Project Number 11233-04
Permit No. 04030-10000-02507

RE: **Response to City of Los Angeles Compaction Report
Correction List** – Proposed Office/Warehouse Project – Located at
1451 West Knox Street, in the City of Los Angeles, California (Lot 8,
Tract 52172)

City of Los Angeles COMPACTION REPORT CORRECTION LIST

Plot Plan

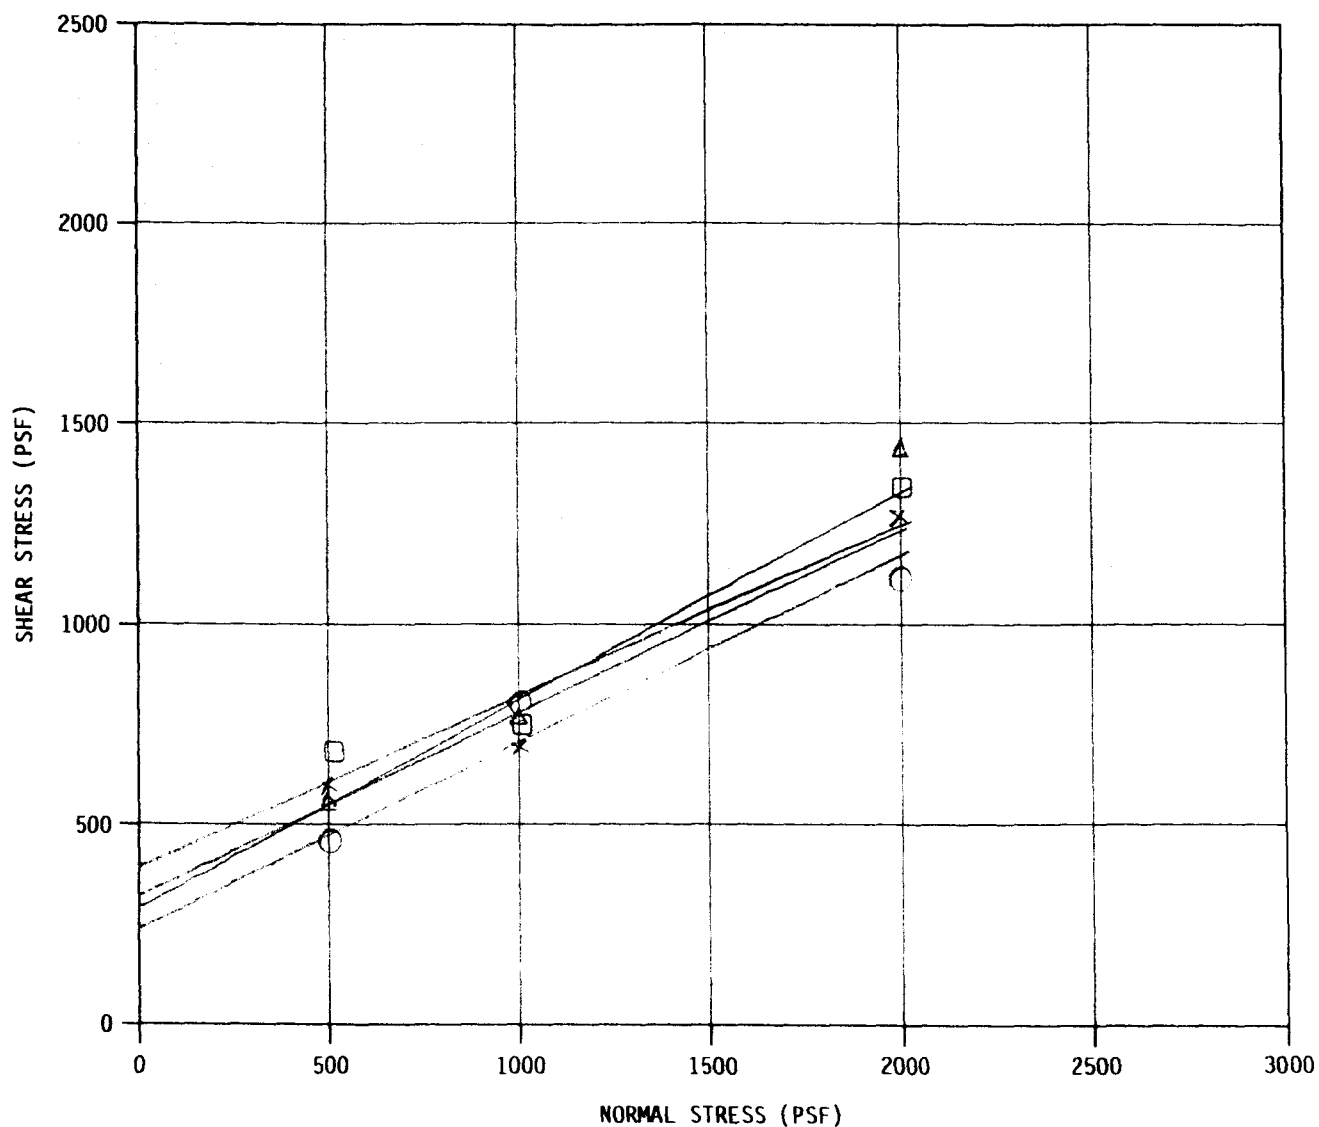
- ②⑥ PROVIDE A COPY OF THE REVISED SOILS REPORT (11233-04) UNDER WHICH YOU RECOMMENDED CHANGE OF USE FROM SECONDARY TO PRIMARY STRUCTURAL FILL.
- ②⑦ ON PAGE 2, YOU STATED THAT A MINIMUM OF 3 FEET OF COMPACTED ENGINEERED FILL IS REQUIRED BELOW/BENEATH FOUNDATIONS. YOUR PLOT PLAN SHOWS FILL ONLY 1 TO 3 FEET AT PLACES. THESE ARE TWO CONFLICTING STATEMENTS. MINIMUM DEPTH OF FOUNDATION IS 24 INCHES. TO HAVE 36 INCHES (BENEATH FOUNDATION) COMPACTED FILL, AT LEAST 6 INCHES OF COMPACTED ENGINEERED FILL IS REQUIRED.
- ②⑧ SILTY SANDY CLAY SOIL IS USED FOR BACKFILL AND COMPACTION. PROVIDE SHEAR VALUE CHART FOR THIS SOIL. IF THIS WAS ALREADY DONE AND PROVIDED IN SOILS REPORT, THEN YOU MAY IGNORE THIS REQUEST.

The depths of fill indicated on the plan included in our January 20, 2005 are
depths of fill placed during the recent grading operations. Fill depths of 10 to 30
feet were already present on the subject property prior to recent grading, placed
during previous mass grading operations on the Boeing property and approved
by the City of Los Angeles. The required fill blanket beneath foundation is
therefore present in all areas.
